CUI DEVICES

Product Change Notice (PCN)

PCN Number: PCN-0460231R-01**To Our Customers:**
We appreciate your use of CUI Devices products. Our commitment in maintaining and improving processes is demonstrated by plans to enhance our product quality, reliability and manufacturability. The purpose of this notice is to inform you of a product change.

Product(s) Affected: TB009-508 series
TB009-508-02BE, TB009-508-03BE, TB009-508-04BE, TB009-508-05BE, TB009-508-06BE, TB009-508-07BE, TB009-508-08BE, TB009-508-09BE, TB009-508-10BE, TB009-508-11BE, TB009-508-12BE, TB009-508-13BE, TB009-508-14BE, TB009-508-15BE, TB009-508-16BE,

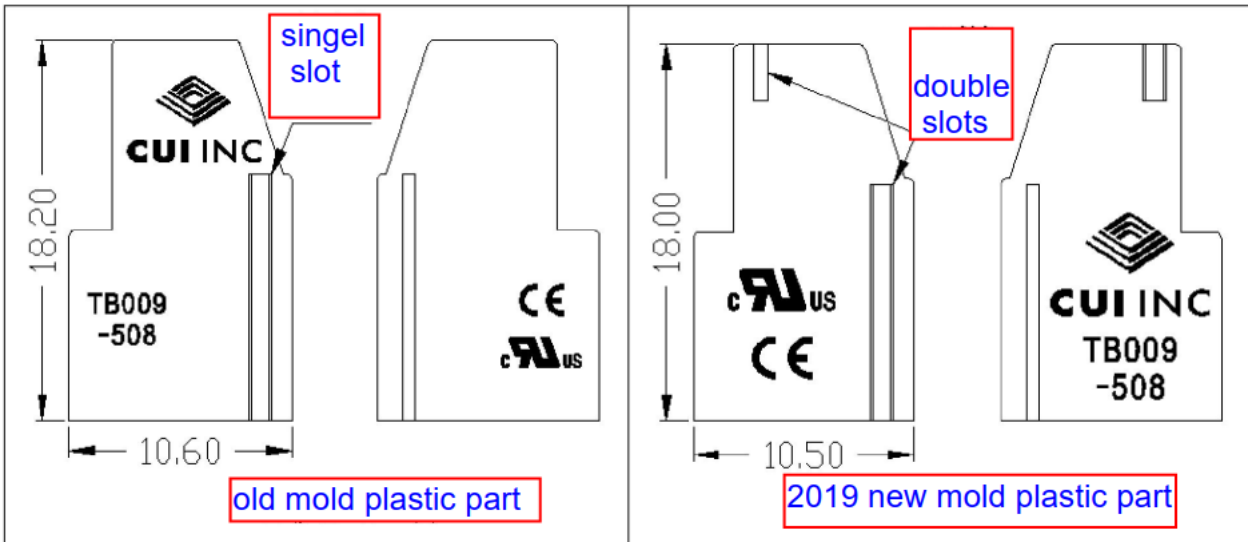
Reason(s) for Change: To promote the efficiency of automated assembly machine.

Description of Change: Additional slot for ease of configuration as shown below:

Additional Information: Products using the old mold cannot be connected to products using the new mold.
